RELAY REPLACEMENT PROCEDURE – GPN2010V, GPN2012V, GPN2213V and GPN2214V PANELS

Figure IV – Electro-Mechanical vs. Solid State Relay

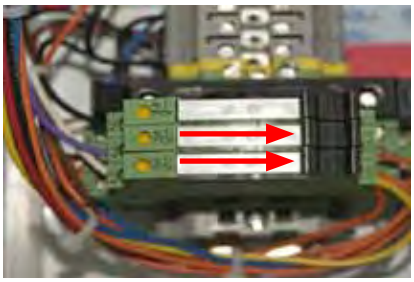
4. Remove the relay cartridge and destroy/discard.
5. Insert the blue solid state relay into the carrier seat. **Note the lead pattern on the bottom of the relay (Figure IV). The relay must be oriented so that this pattern matches up to the pattern in the carrier.** Also note that it has one less pin than the relay that you just removed **(Figure IV)**.

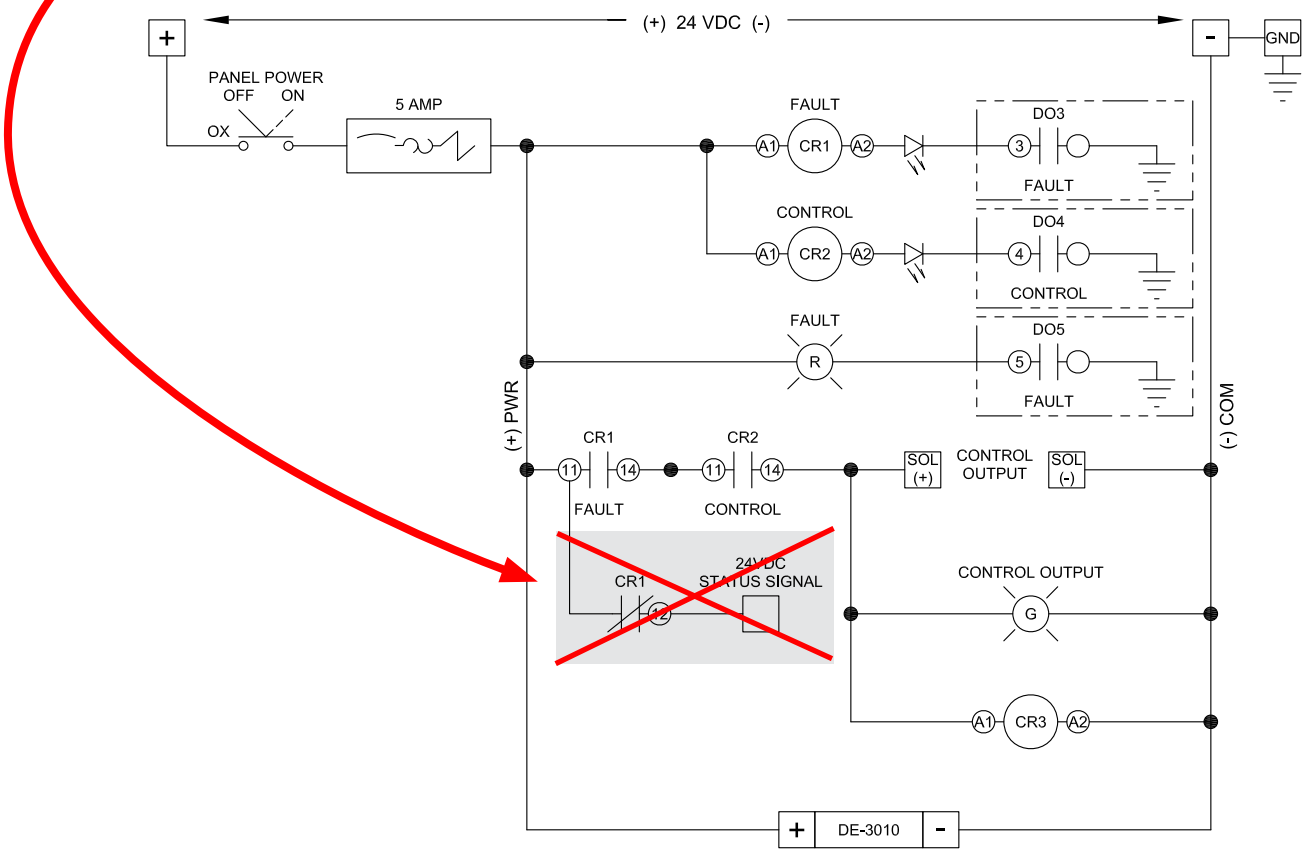
The electromechanical relays being replaced under this notice contained a second set of contacts that are not present in the new solid state relay. These contacts are shown in the grey box in **Figure VI**. The purpose of these contacts was to allow for the use of a remote alarm/warning when the FAULT relay tripped. With the new solid state relay, this feature is no longer available.
